CITY OF CODY
PLANNING, ZONING AND ADJUSTMENT BOARD
TUESDAY, MARCH 24, 2020
CITY HALL COUNCIL CHAMBERS @ 12:00 NOON

CITY OF CODY PLANNING, ZONING AND ADJUSTMENT BOARD STAFF REPORT			
MEETING DATE:	MARCH 24, 2020	***TYPE OF ACTION NEEDED***	
AGENDA ITEM:		P&Z BOARD APPROVAL:	X
SUBJECT:	SPECIAL EXEMPTION PUBLIC HEARING: REDUCE THE SIDE SETBACK REQUIREMENT AT 802 DUESENBERG COURT. SUP 2020-04	RECOMMENDATION TO COUNCIL:	
PREPARED BY:	TODD STOWELL, CITY PLANNER	DISCUSSION ONLY:

CITY OF CODY PLANNING, ZONING AND ADJUSTMENT BOARD STAFF REPORT			
MEETING DATE:	MARCH 24, 2020	***TYPE OF ACTION NEEDED***	
AGENDA ITEM:		P&Z BOARD APPROVAL:	
SUBJECT:	PRELIMINARY PLAT OF THE LANDING SUBDIVISION— A 58-LOT SUBDIVISION. SUB 2020-02	RECOMMENDATION TO COUNCIL:	X
PREPARED BY:	TODD STOWELL, CITY PLANNER	DISCUSSION ONLY:

CITY OF CODY PLANNING, ZONING AND ADJUSTMENT BOARD STAFF REPORT			
MEETING DATE:	MARCH 24, 2020	***TYPE OF ACTION NEEDED***	
AGENDA ITEM:		P&Z BOARD APPROVAL:	X
SUBJECT:	SITE PLAN REVIEW: PARK COUNTY CORONER'S BUILDING. SPR 2020-05	RECOMMENDATION TO COUNCIL:	
PREPARED BY:	TODD STOWELL, CITY PLANNER	DISCUSSION ONLY:

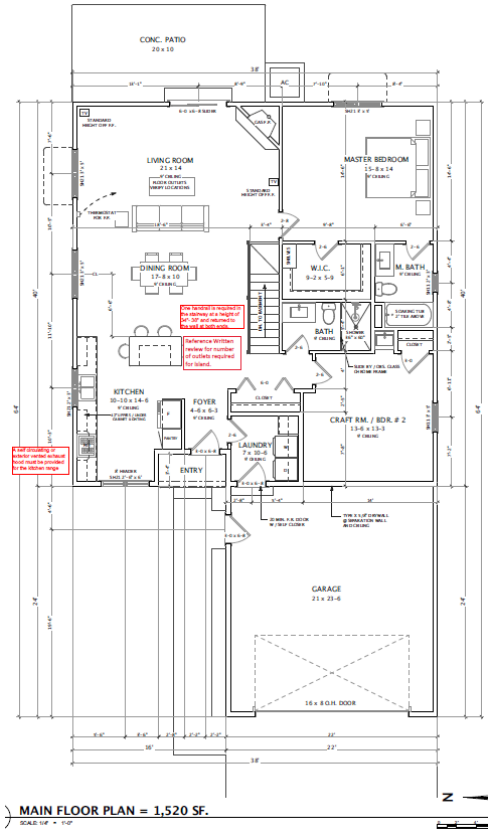
Staff Comment: Reducing the width of the house by seven feet to meet the setback requirement would severely impact the functionality of the interior of the house—see floor plan on next page. The house design is not excessively large either, at 1,520 sq. ft. and a two-car garage. The request does not seem excessive.

THE LANDING

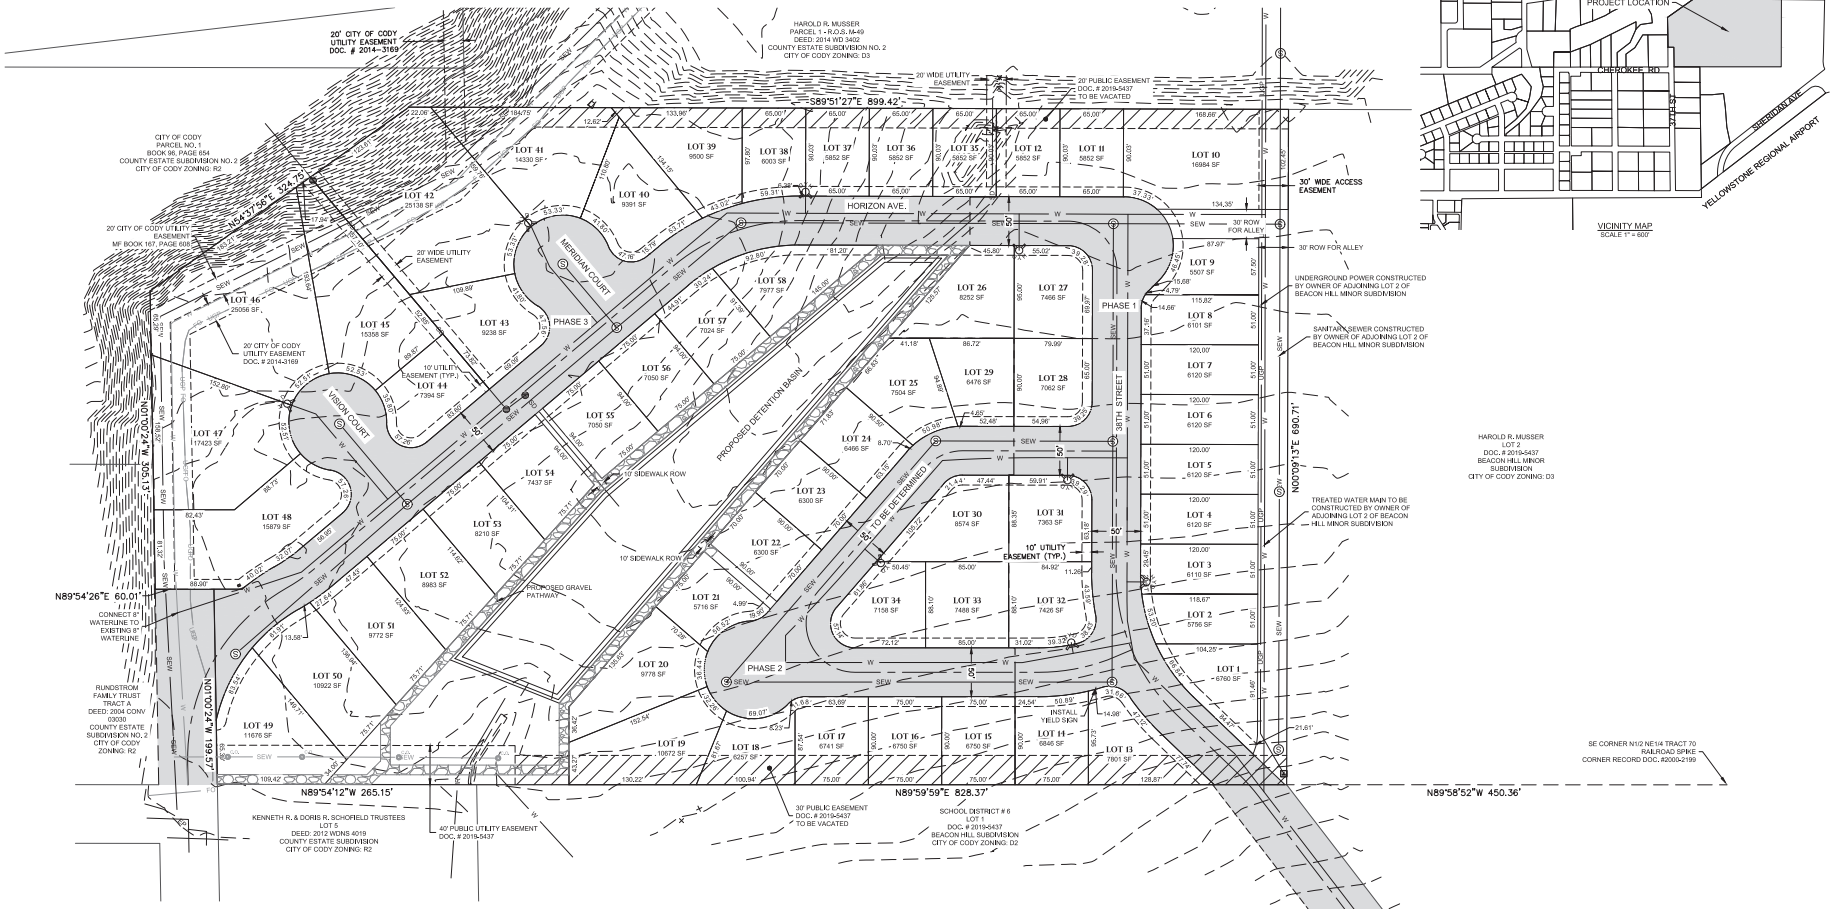
A. Alignment: All proposed streets, alleys and easements shall align horizontally and vertically with existing streets, alleys and easements adjacent to or lying near the subdivision.
Comment: The proposed streets will tie in to Sheridan Avenue and 37th Street in a manner that will match those existing streets. (Note: While the preliminary plat drawing shows the streets ending at the right-of-way line, they will need to extend to the actual paved street.) In order to match alignments, it is expected that some reworking of the 37th and Cherokee intersection may also be needed. The construction plans submitted with the final plat will need to include such details.

Comment: Until Phase 3 (the area west of the detention basin) is constructed, there will be a dead-end street at the north end of Phase 1. While the turnaround does not meet the full cul-de-sac dimensions normally required, the fire marshal is okay with the turnaround provided as a temporary situation. The alley will also be available for turnaround use.

Comment: The alignment of 38th Street coming into the subdivision does not clearly meet this standard, yet the alignment of this section of street needs some engineering work in general. It is also noted that the curb at the north end of 37th is not drawn in tangent to the street to the northeast, which needs fixed. The applicant's engineer should review the designs and if necessary, discuss with the Public Works Director.

Comment: The subdivision ordinance has not been updated to reflect the street profiles of the street master plan, so a variance is requested to the right-of-way width. The proposal would provide a 50-foot wide right-of-way as shown in the street master plan, plus a 10-foot utility easement to each side of the right-of-way, which is adequate to accommodate the street design. Grades will be verified in the construction plans.

Comment: A 30-foot wide alley, with a 20-foot wide driving surface is proposed behind the lots along the east end of the subdivision. The applicant requests a variance to the alley requirement for all other lots. It is noted that alleys are not needed in this case for garbage collection. Garbage collection will be with roll outs.

Sewer and Water Main on North Street/Utilities
We have flipped the water and sewer main in the section of street east of lot 38. Additionally, we added the underground power that Harold Musser intends to install.

The street right of way throughout the subdivision was increased to 50 feet. Also, the curve by Lots 1 and 2 and off of 37th Street were increased to 200-foot radius. The corresponding lots were updated, and the lot count was reduced to 58 as a result.

DATE: 01/08/2020
PROJECT: 190598
SHEET: C1.00

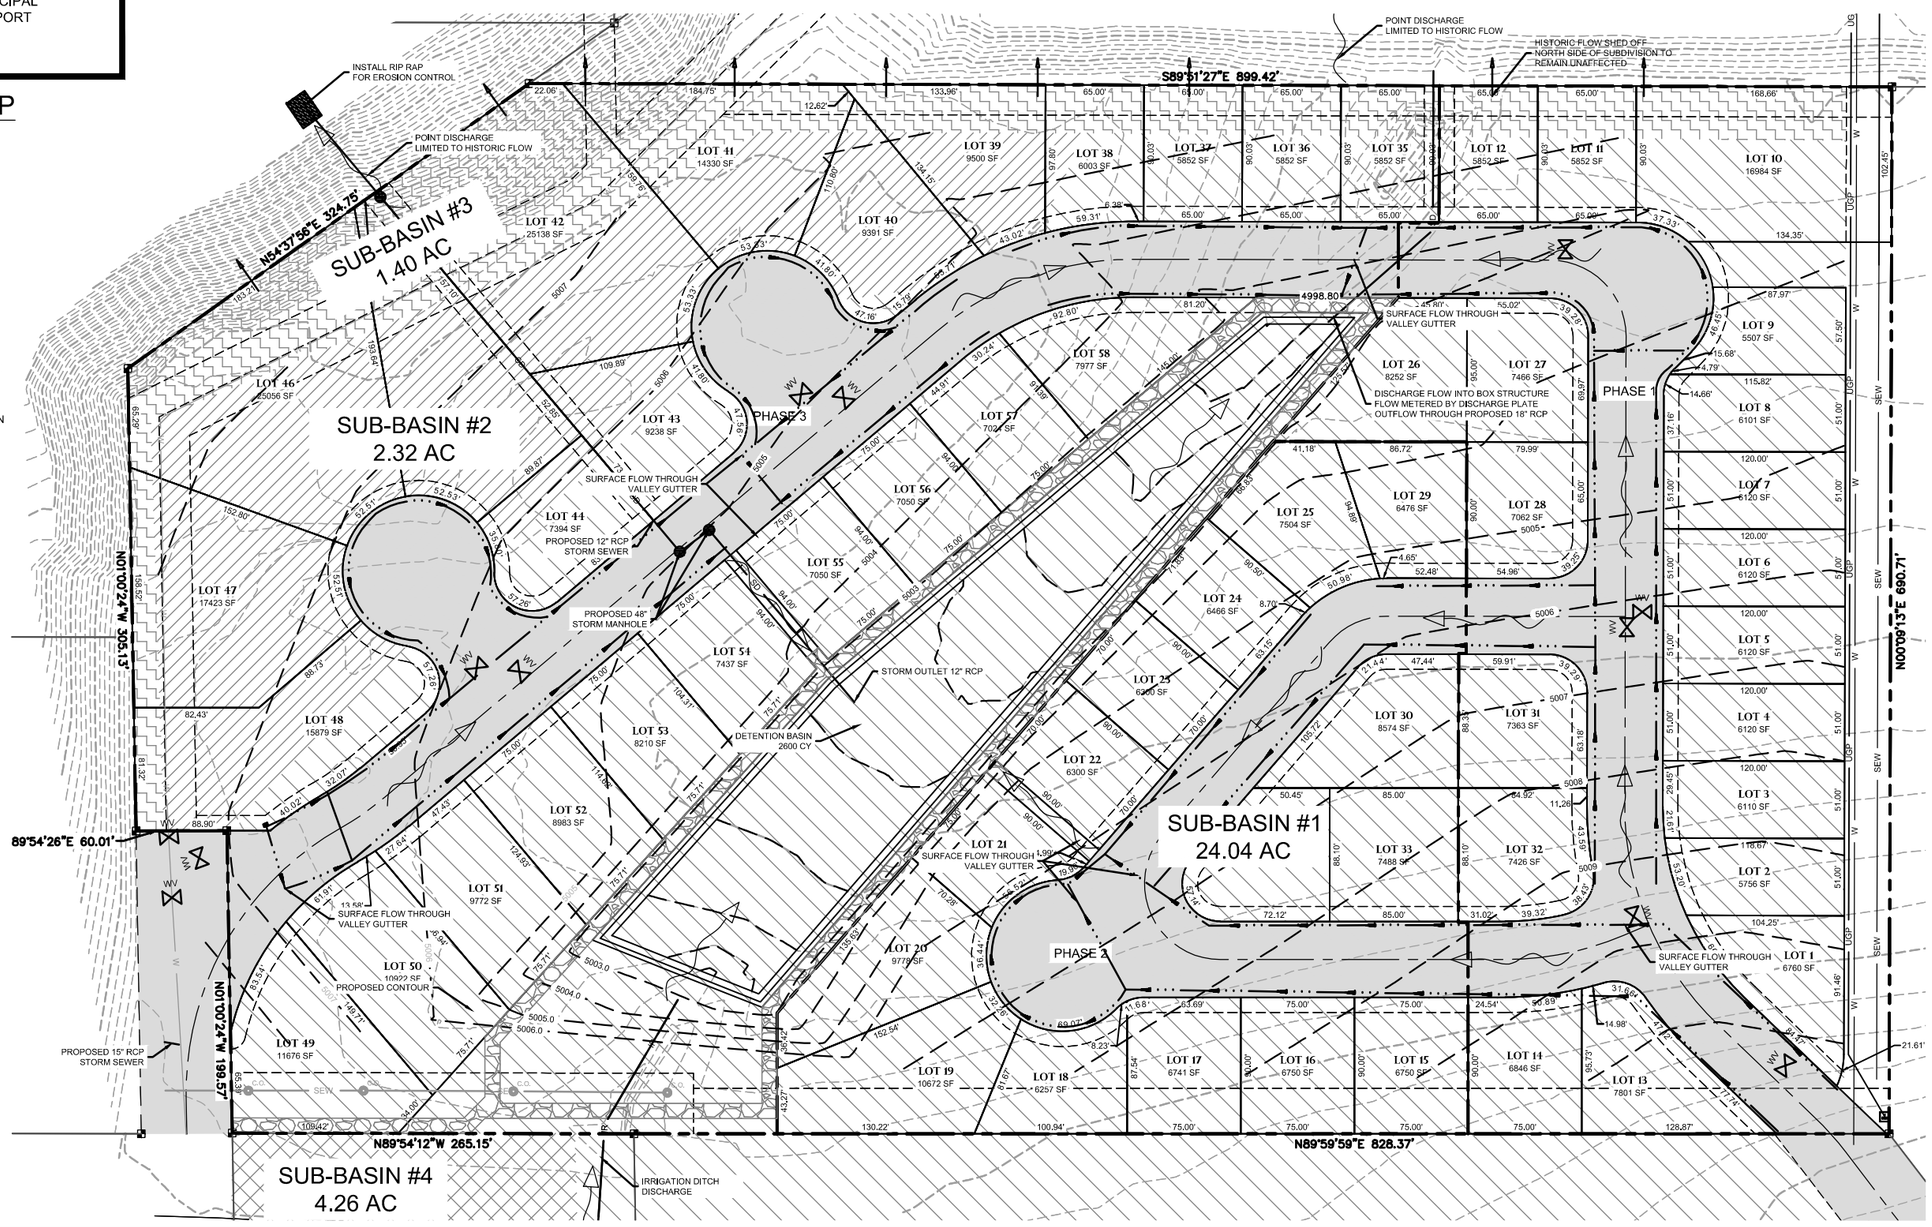
Comment: A preliminary drainage design has been provided (see attached). With the exception of Sub-basin #3 which is hillside and not affected by the subdivision, all drainage will be directed to the proposed detention basin in the middle of the subdivision. The basin will be constructed to detain the 100-year 2-hour storm, with discharge points to slowly release the water.

Public Works requests the following changes or clarifications to the storm water plan. They will need to be reflected in the final storm water plan submitted with the preliminary plat.

basin for that water. That discharge would be onto City property, and quickly into a private drainage ditch that has questionable capacity. We believe this storm water discharge pipe should be eliminated.

b) The drawing shows a point discharge (wrong location, but that is not the issue), at the north property line. Staff understanding of WY water law is that historical discharge rates are allowed at historical locations, but that no point discharge can be created without permission of the receiving property owner. To avoid the point discharge, the pipe will need to be ended sufficiently before the north property line that the water can be dispersed in a historical sheet flow (e.g. rip rapped and graded area).

c) Clarify the existing/historical grade break between flow towards the hillside to the northwest and flow eastward. Be sure the final drainage report analyzes this appropriately.

The new design will require the open area dividing the Subdivision at the center of the development to be graded to detain all surface flows from Sub-Basins 1, 2 and 4 (as shown on the attached drainage plan), as well as, the small lateral ditch entering the property from the South. Note that Sub-Basin 3 is that acreage on the far north and west of the subdivision where capture of storm runoff is impractical due to existing topography. The detention basin will be designed to hold a water volume equivalent to a 100-year, 2-hour storm. After a brief analysis of the anticipated flows, the open area will be able to detain this volume until discharge can slowly release the water.

SHEET #
L1.0
LANDSCAPE

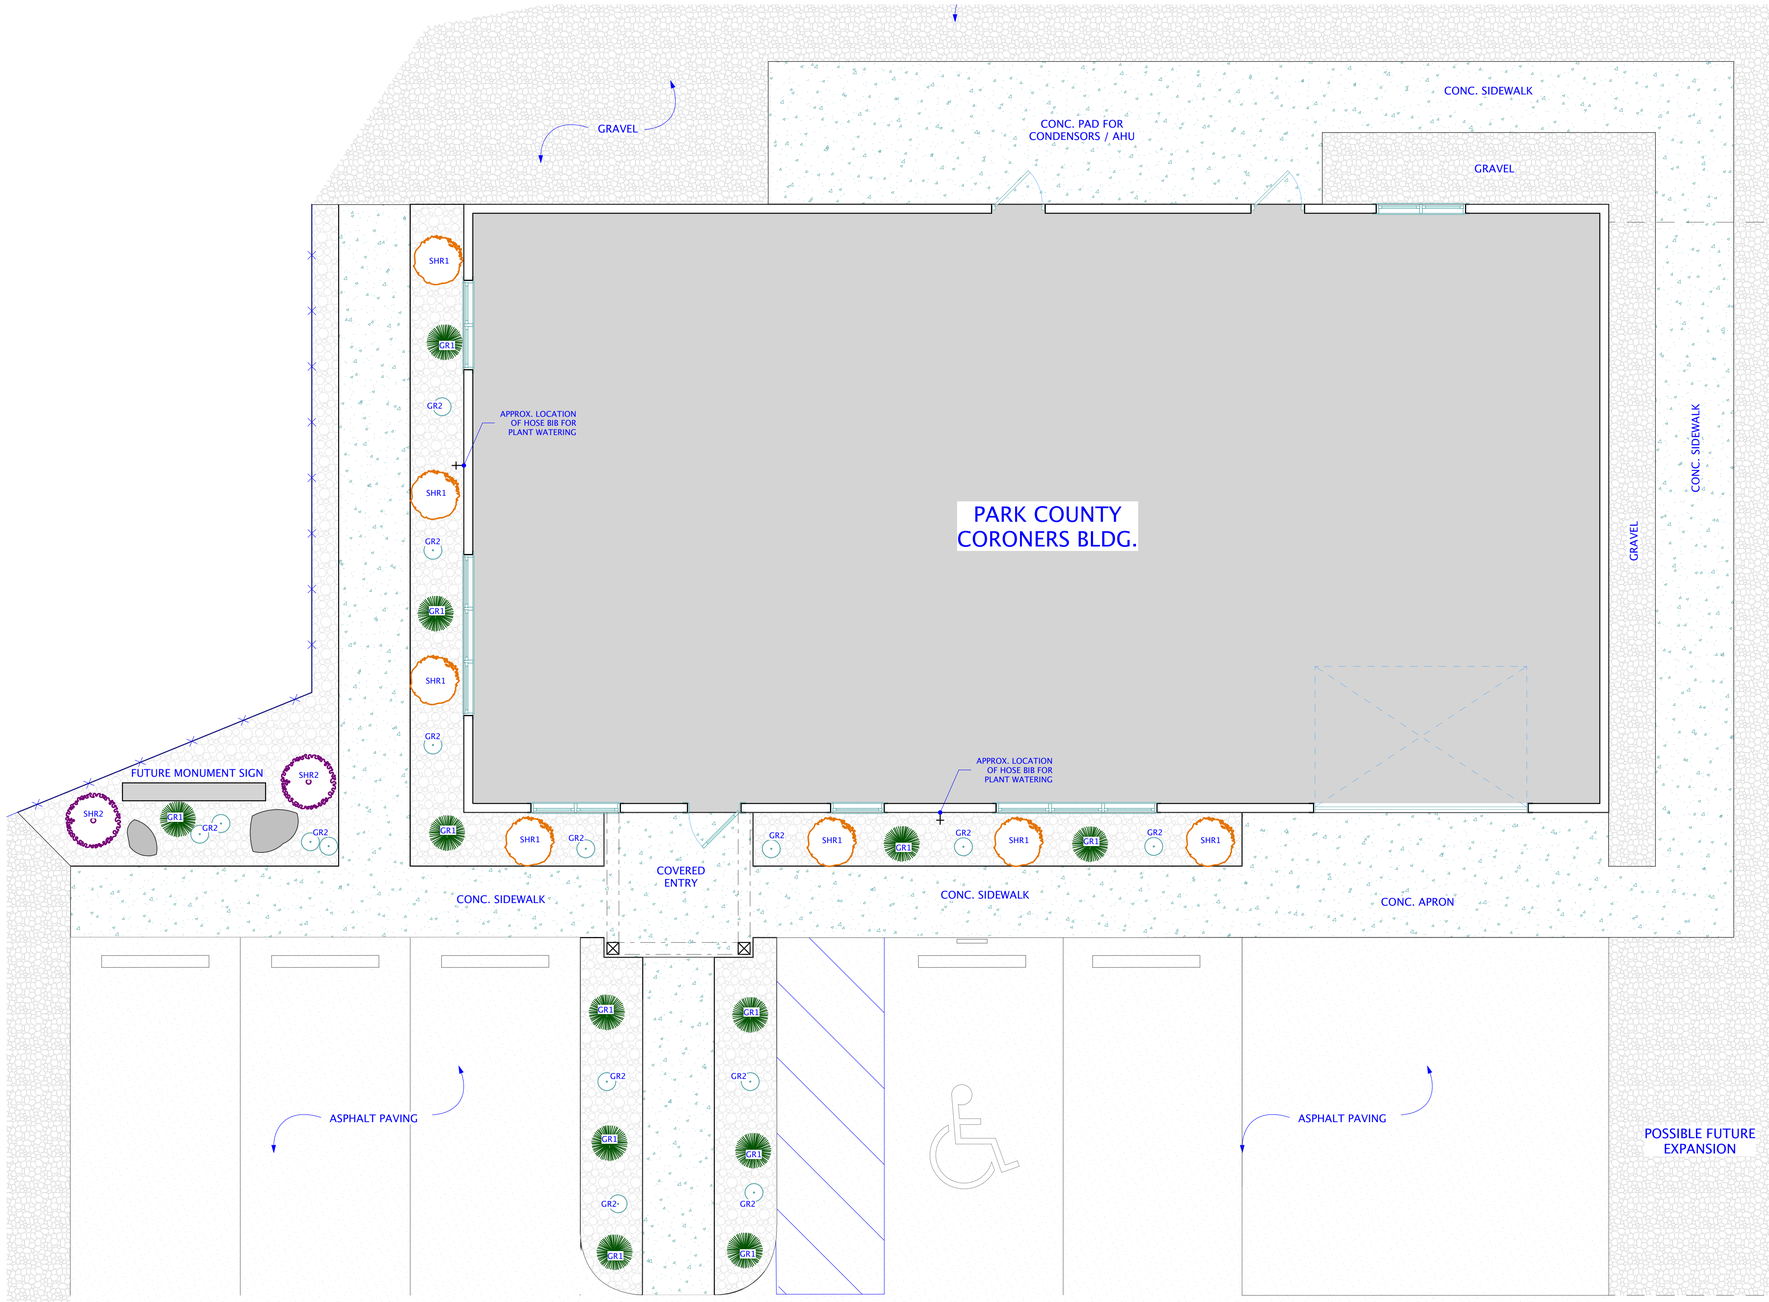
The landscaping plan is shown on Sheet L1.0. It includes 3-foot deep planter beds along the west and south portions of the building, and landscape islands to each side of the sidewalk to the entryway. The plan calls for shrubs and grasses suitable for the climate in a gravel bed. Hose bibs are shown as being provided for watering.

The property is within the entry corridor overlay, which has the requirement for 5% of the property to be in landscaping. With the existing landscaping already in place, there is approximately 6% of the property in landscaping. The landscaping plan appears suitable to meet minimum standards.

1 E1.1 LIGHTING PLAN

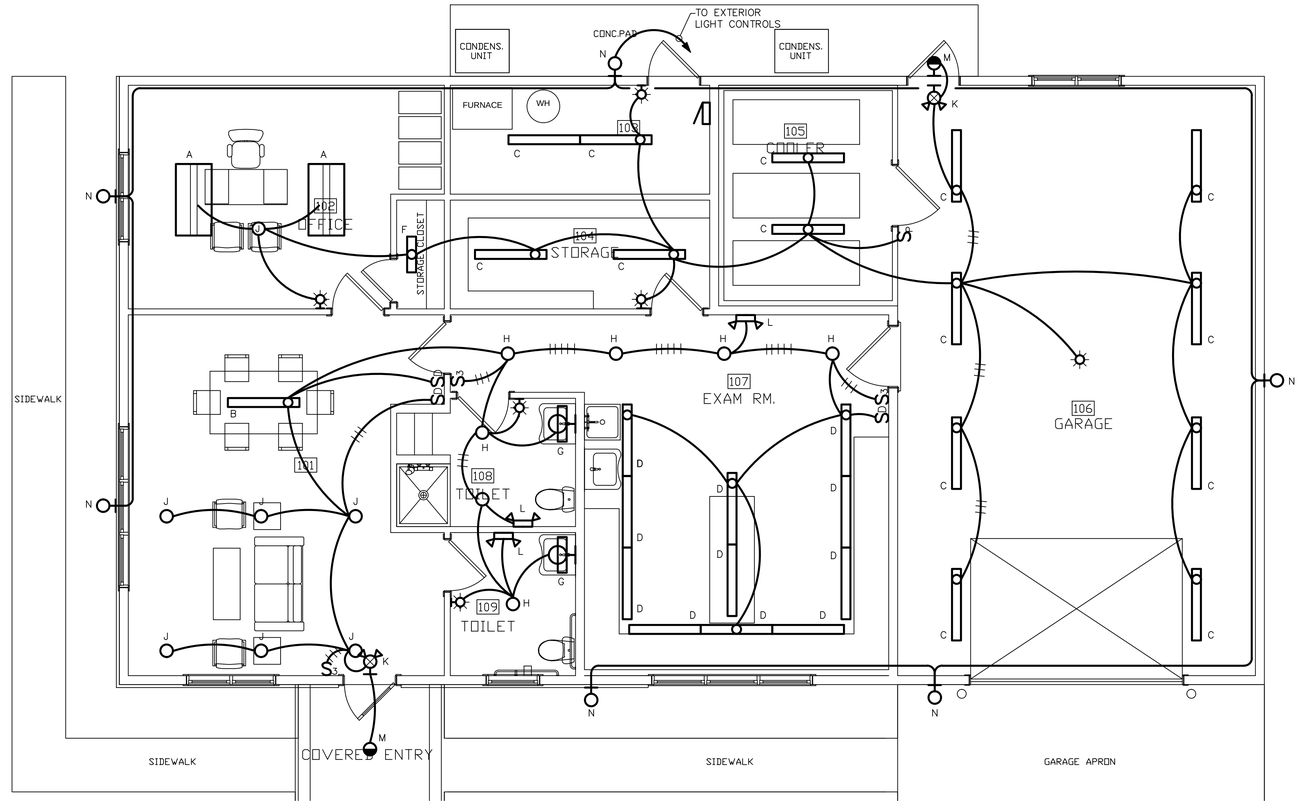
The electrical plan (Sheet 1.1) shows six exterior LED cut-off style wall packs on the building. The fixture selected would each produce 6,635 lumens, which seems excessive. Staff believes it appropriate to ask what is the intent of so much lighting—what are they trying to light up, and also if it be on throughout the night, or on a timer. It would appear that the smaller option of the same fixture style would be more appropriate (likely the 20-watt version instead of the 60-watt version). If the applicant is not willing to voluntarily reduce the illumination to the 20-watt version, they should provide a photometric map showing site lighting levels for Board review.
